**TYPE III –Master Plan and Detailed Development Plan
SUPPLEMENTAL FINDINGS FOR ADDITIONAL ADJUSTMENTS
STAFF REPORT AND RECOMMENDATION**

September 1, 2017

FILE NUMBER: CP-17-0002: General Development (Concept) Plan
DP-17-0003: Detailed Development Plan for Phase 1
NR-17-0004: Natural Resource Overlay District Verification

Approval for General Development Plan for Abernethy Place, a mixed-use project including Hotel, Multi-Family, Retail/Commercial and Office Use to be constructed in two phases over 10-years as well as a Detailed Development Plan for Phase 1 which includes construction of a Hotel and parking lots.

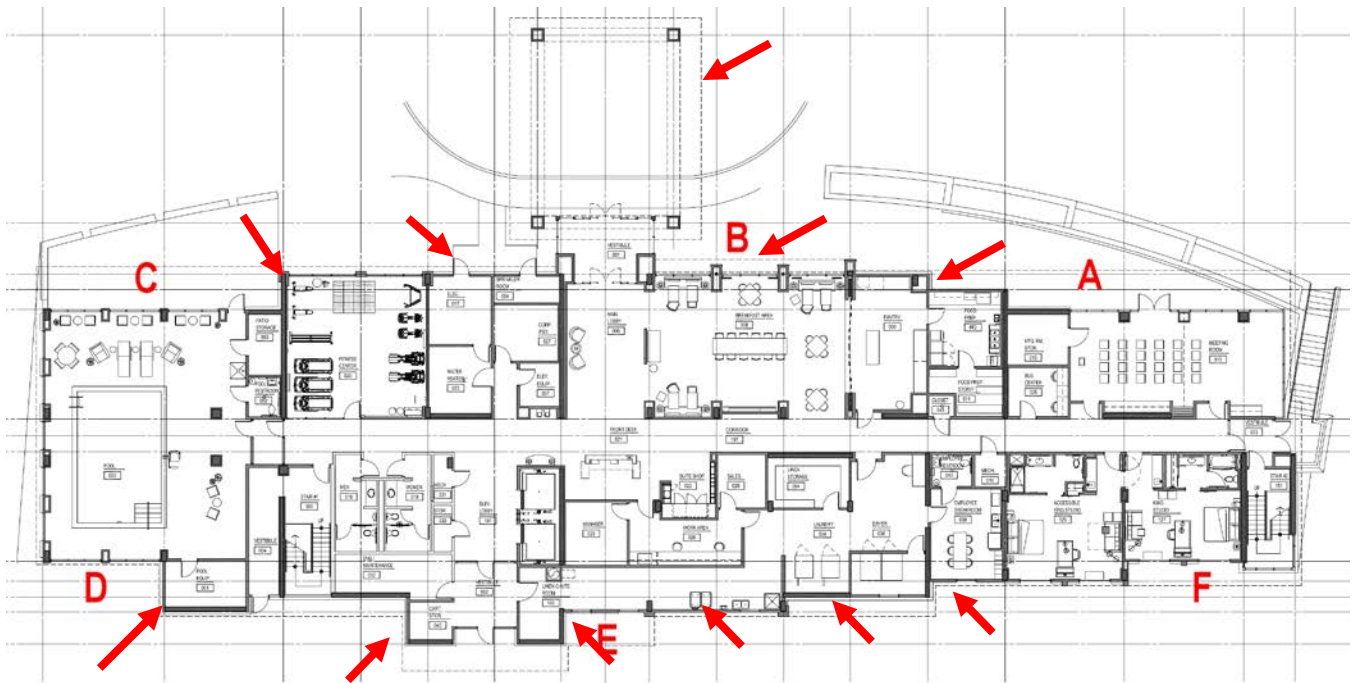
The North and South facades are both approximately 238 feet long. The east and west facades are less than 100 feet in length. The standard applies to the North and South facades and requires a projection or recess of 3% of 238 feet or 7.14' for a minimum length of 20% of the length of the façade, or 47.6 feet.

North Facade: At the lobby level, the large windows located at 'A' and 'C' are recessed approximately 7.23 feet back from the wall plane located at 'B' meeting the depth standard. The recessed wall at 'A' is approximately 55

feet long, and 'C' is approximately 45 feet long. At the top of the building the face of the wall and parapet are recessed between 7.7 feet and 11.5 feet back from the face of the parapet at the center of the building, a distance of approximately 68 feet, which meets the standard. At floors 2 thru 5 the wall planes located at 'G' and 'I' are recessed approximately 6.8 feet back from the wall plane at 'H' [a recess of 2.8%] for a length of 56 feet and 45.5 feet respectively. Additional recesses also occur at several locations [see arrows], further adding to visual relief of the facade.

South Façade: At the ground level, the wall planes located at 'D' and 'F' are recessed approximately 9.5 feet back from the wall plane located at 'E', meeting the depth standard. The recessed wall at 'D' is approximately 23 feet long, and 'F' is approximately 33 feet for a total of approximately 56 feet, which meets the standard. At the top of the building the face of the wall and parapet are recessed between 7.7 feet and 11.5 feet back from the face of the parapet at the center of the building, a distance of approximately 68 feet, which meets the standard.

At floors 2 thru 5 the wall planes located at 'L' and 'J' are recessed approximately 6.8 feet back from the wall plane at 'K' [a recess of 2.8%] for a length of 56 feet and 45.5 feet respectively. Additional recesses also occur at several locations [see arrows], further adding to visual relief of the facade.

Finding: Complies as proposed. In addition to the purpose of the MUD District, the purpose of the requirement is to allow for visual interest and provide visual relief by breaking up the massing of a large wall into smaller segments. As described by the applicant, the adjustment is proposed for floors 2 thru 5. The applicant has met the intent of the standard by providing more than the minimum length of the articulation and by offsetting the articulation. In addition, the proposed design includes a variety of building materials, windows, and landscaping which create the same overall effect of providing visual relief and deconstructing a large building into smaller segments. The applicant's description of the proposed adjustment #5 to reduce the depth of required wall plane projections or recesses from three percent to 2.8 percent, and further clarify that multiple projections or recesses have been added to achieve the required percentage overall on the various facades has adequately addressed the purposes of the MUD zone.

LOBBY FLOOR

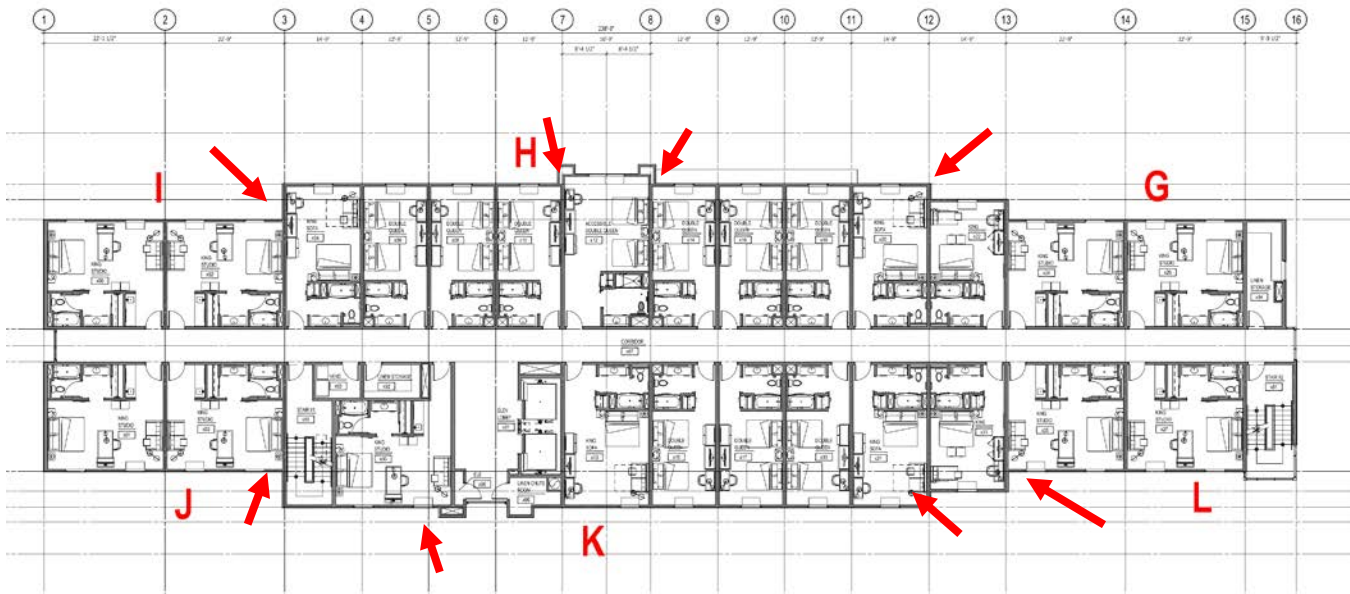
The proposed design provides building articulation at the parapet which exceeds the requirements of the code. This parapet articulation will be the most visible when the building is viewed either from a distance or from pedestrians in close proximity to the building. The proposed design also provides building articulation at the ground level which exceeds the requirements of the code. This ground level articulation will be most visible to pedestrians when they are in close proximity to the building. Finally the proposed design provides articulation at floors 2 through 5 which is within a few inches of complying with the standard. The articulation at floors 2 through 5 will be difficult for people viewing the building to perceive since it cannot be judged at either the ground level or at the parapet, and it is difficult to assess the depth of the articulation of these floors when viewed either from a distance or from close proximity to the building. Furthermore the design includes additional architectural features which, although they do not technically comply with the design standard, add depth and interest to floors 2 through 5.

At the lobby floor and parapet where the articulation will be most visible, the wall articulation standard is met or exceeded. At floors 2-5 the length of required articulation exceeds the minimum, while the recess is approximately 4" less than required. Additional articulation is provided at all floors providing cumulative façade articulation exceeding the requirements. Variation between articulation at lobby, roof, and upper floors adds additional variation, further mitigating façade articulation.

Finding: Complies as Proposed. The standard requires a projection or recess of 3% of 238 feet or 7.14' for a minimum length of 20% of the length of the façade, or 47.6 feet. This standard could met by providing a single recess of the required depth and length on all building walls. Instead, the applicant's proposal for floors 2 thru 5 the wall planes located at 'L' and 'J' are recessed approximately 6.8 feet back from the wall plane at 'K' [a recess of 2.8%] for a length of 56 feet and 45.5 feet respectively. Additional recesses also occur at several locations [see arrows], further adding to visual relief of the facade.

There are in total 7 changes in plane varying in length from 14' long to 52' long on floors 2 through 5. Therefore, while the depth of any single articulation does not meet the full 3% depth for 20% of the length in all cases, the cumulative effect of these additional articulations is provided at all floors. Furthermore, the applicant has proposed to exceed the minimum 30% transparency requirement on the North side façade at the pedestrian level with 42% transparency. Multiple building material texture changes consisting of wood texture, fiber cement panels, smooth plaster, and architectural metal have been proposed. Four rows of 18 windows per floor are proposed on floors 2 through 5 on both the North and South facades. Cumulatively, these design aspects adequately mitigate for the adjustment.
